Bury Interchange – Phase 1

Non-Material Amendment Design Document

Design Changes Summary

Platform Elevations

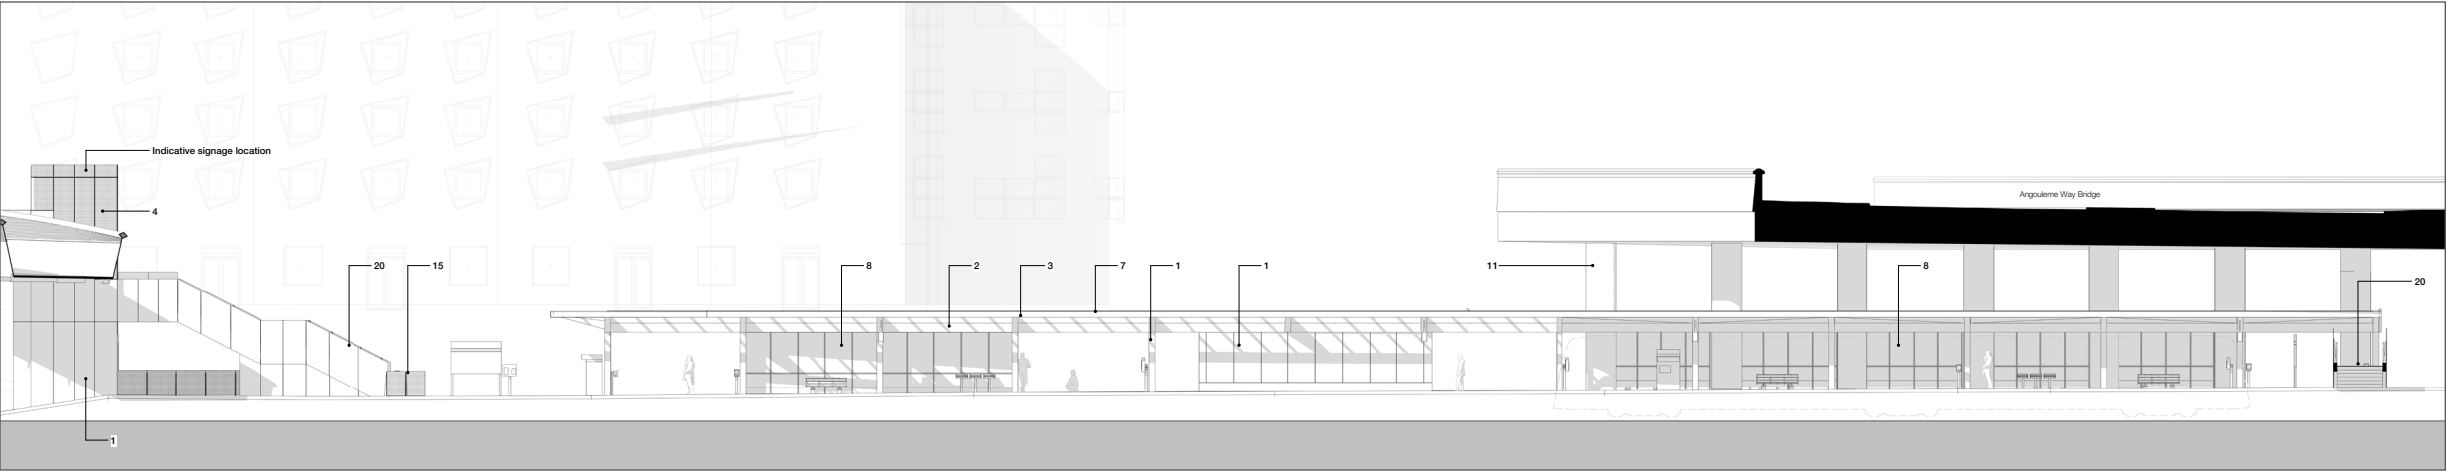
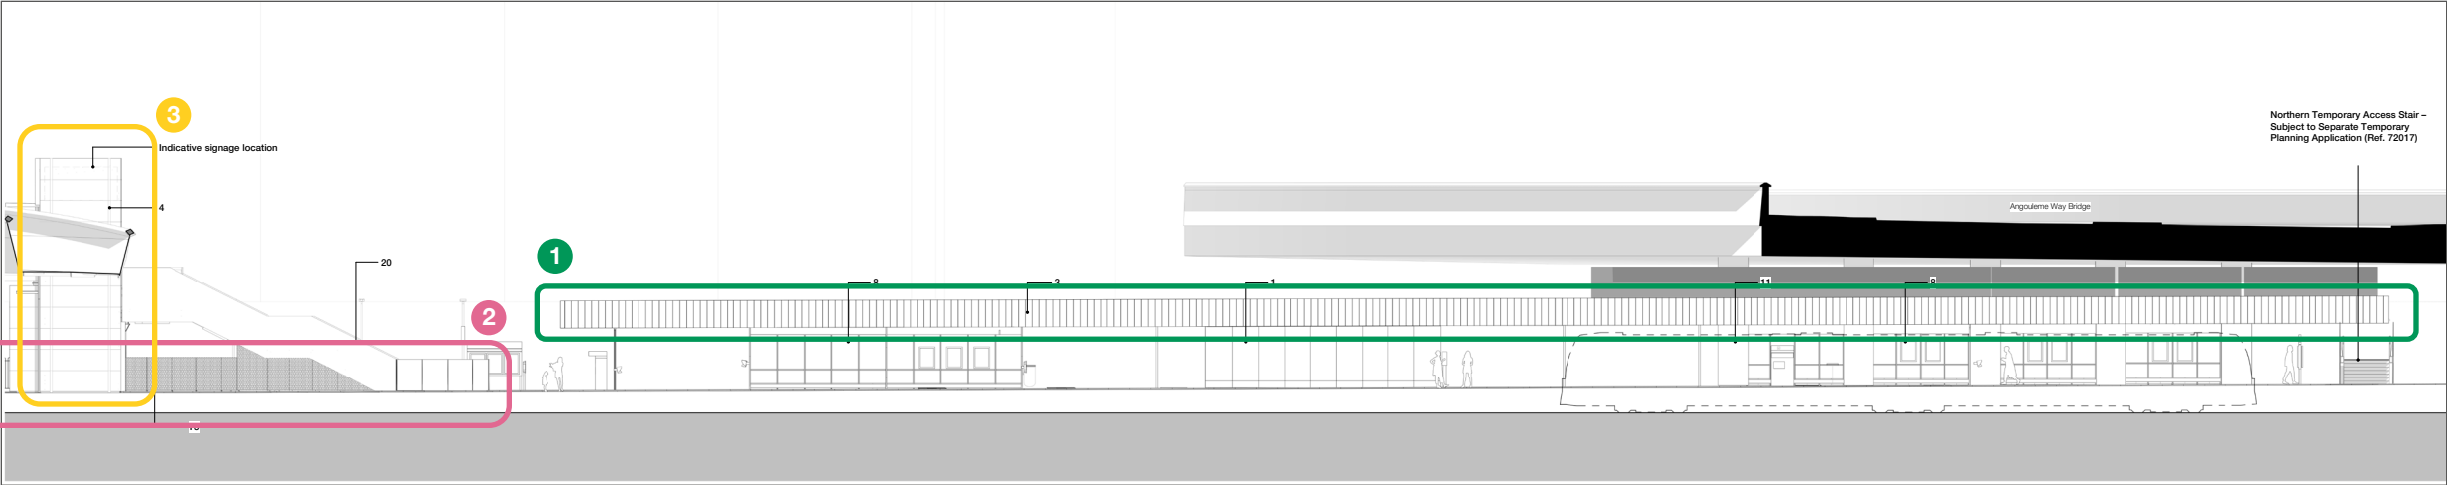
- Canopy width, profile, proportions, and height have been further developed to allow the canopy to be located outside of the Metrolink OLE hazard zone.
- Canopy fascia materiality reviewed to strengthen link with the southern access bridge
- Glazing to canopy omitted to simplify maintenance strategy and to align with updated canopy form
- Cladding strategy to existing columns revisited. Cladding omitted to maximise circulation space to the platform

- Amendments to end of platform arrangement. Ramped track access replaced with gated and stepped access to track
- Minor amendments to door positions and inclusion of louvred door panels to platform SER room
- Minor amendments to platform drainage channel positions and finish
- Guarding to base of southern access stair extended due to platform level changes

Union Square

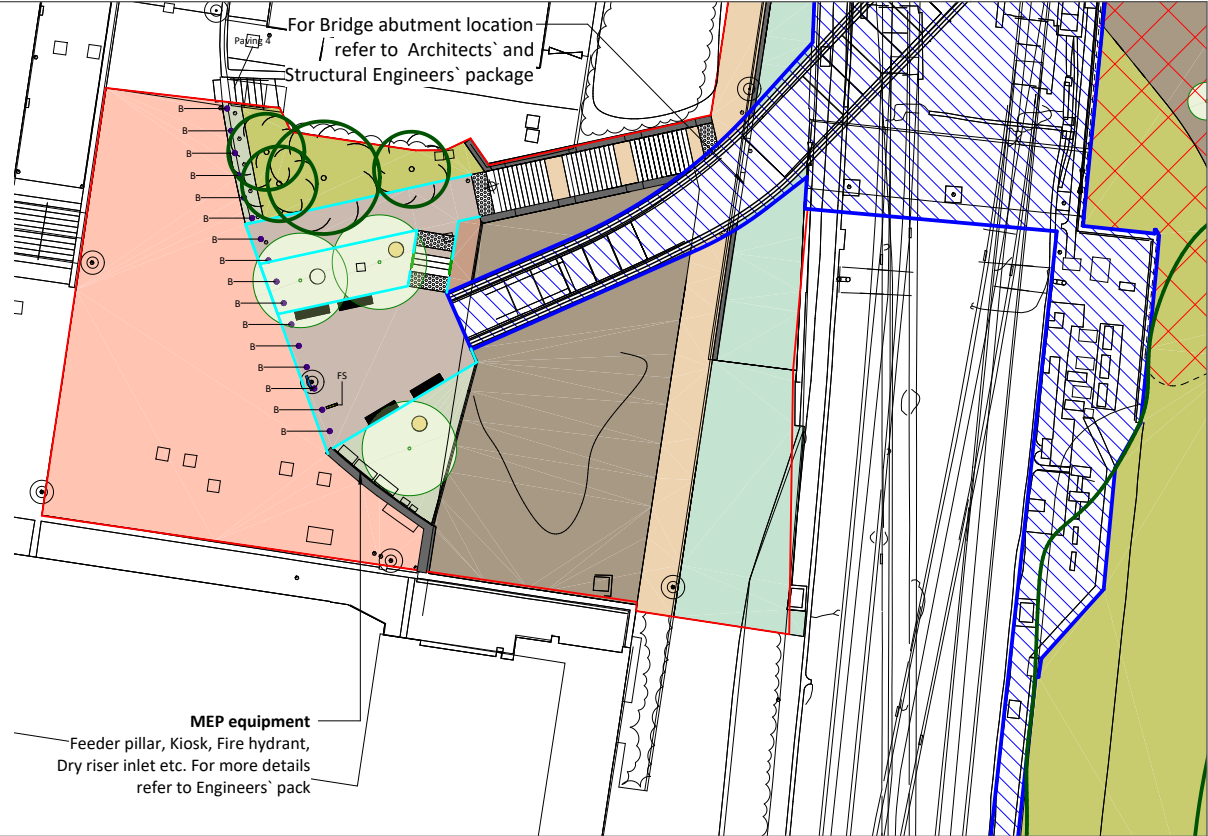
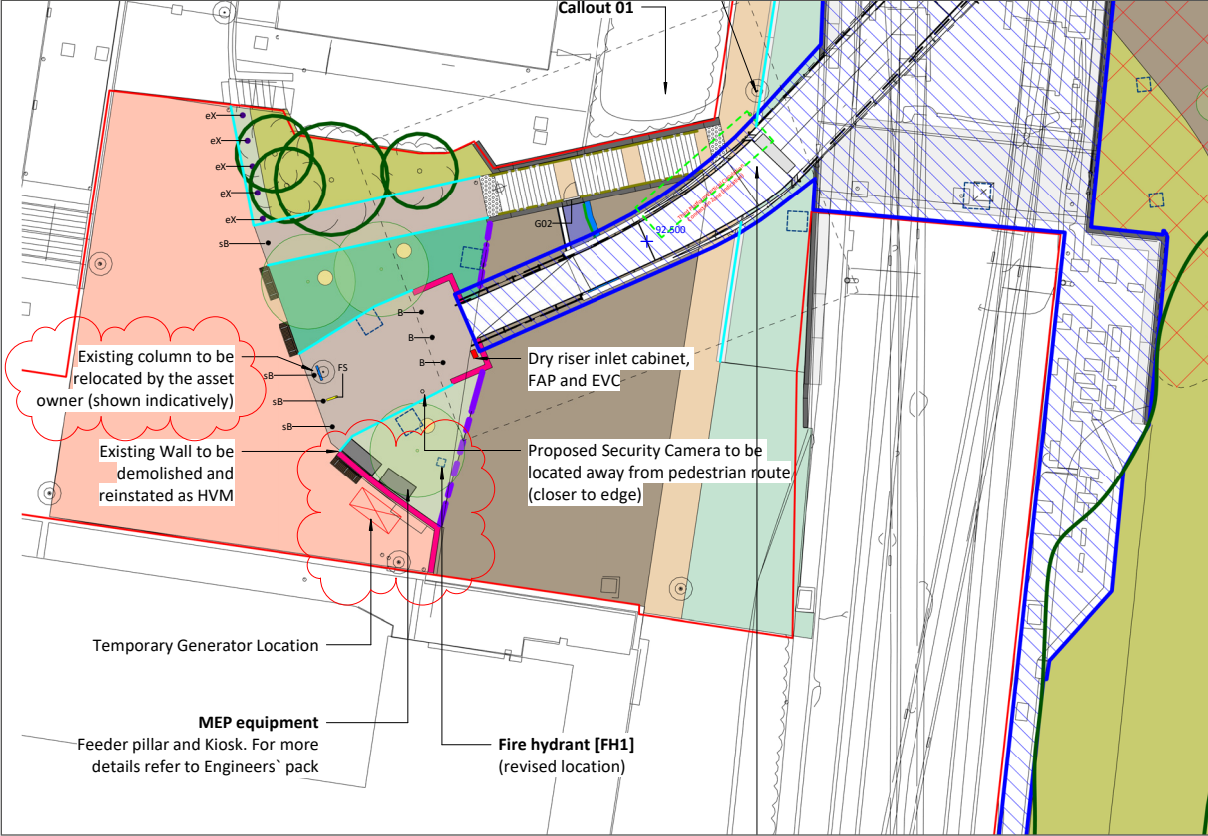
- Union Square soft landscaping reconfigured following layout changes and removal of the external steps; the approved planting specification and BNG delivery remain unchanged
